ADDENDUM NO. 4

RE: Professional Boulevard Bridge W5001 over Antietam Creek and
Road Grading Sta. 21+23 to 52+63
Washington County Contract Number: RD-PB-244-10

**PROFESSIONAL BOULEVARD BRIDGE W5001 over ANTIETAM
CREEK and ROAD GRADING STA. 21+23 TO 52+63
Washington County Contract No. RD-PB-244-10**

Professional Blvd Bridge over Antietam Creek MSE (RETAINING WALL) UNDERCUT DETAIL

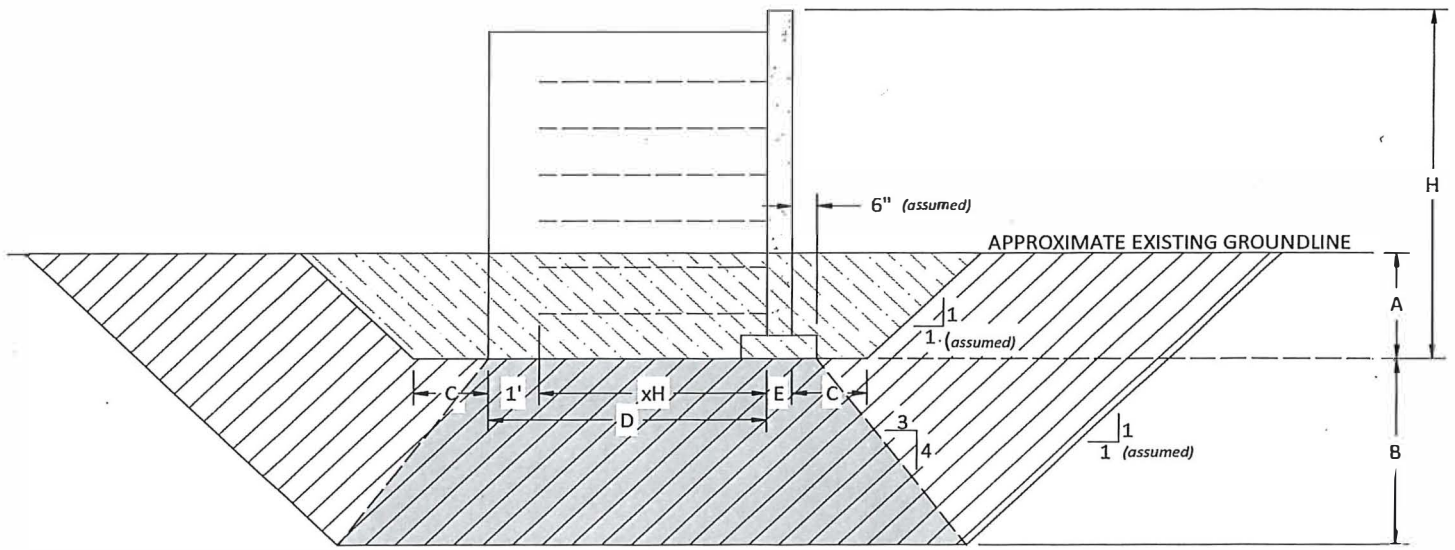
Add Sheet ED-08 to Exhibits and Details in the Bid Document Booklet.

ED-08 details the limits of Class 3 Excavation, Contingent: Undercut and Backfill using Mix 1 Concrete and Contingent: Undercut and Backfill using CR-6.

- .01 DESCRIPTION:** Use Contingent: Undercut and Backfill items when undercut is required to reach bedrock as specified on the Construction Drawings and as depicted in Detail ED-08.
- .02 MATERIALS:** Mix 1 Concrete for Backfill.
CR-6 for Backfill.
- .03 CONSTRUCTION:** Adhere to Special Provision for Retaining Walls and the Undercut notes on the Construction Drawings and Detail ED-08.
- .04 MEASUREMENT AND PAYMENT:** Undercut and Backfill will be measured by the volume of backfill, (Mix 1 Concrete or CR-6), required to complete the backfill and shall be paid for at the Contract Unit Price Bid per cubic yard. Payment will be full compensation for the undercut excavation, backfill, material, labor, testing, equipment, tools, and incidentals necessary to complete the work.
